Subject: Change Order - Jump River - replacement well at Store

Change Order:

Replace water supply well at Country Store (8891 Bridge Rd in Jump River)

Jim's Bar

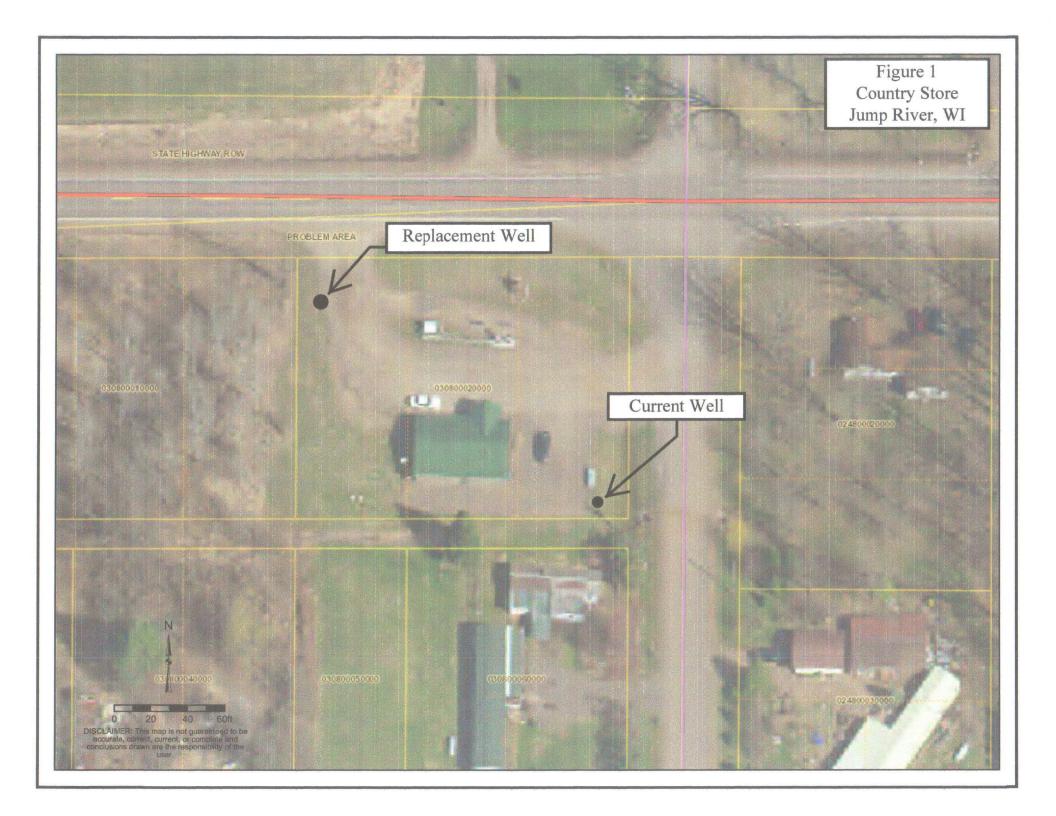
Replace water supply well at Country Store (8891 Bridge Rd – Jump River)(see enclosed Figure)

- Survey property boundaries to insure well is located as far from current location as possible but still within property boundaries
- Install replacement well
- Collect water sample (VOC 524.2) from new well
- If water sample is clean, connect new well to existing water line using directional boring (under building)
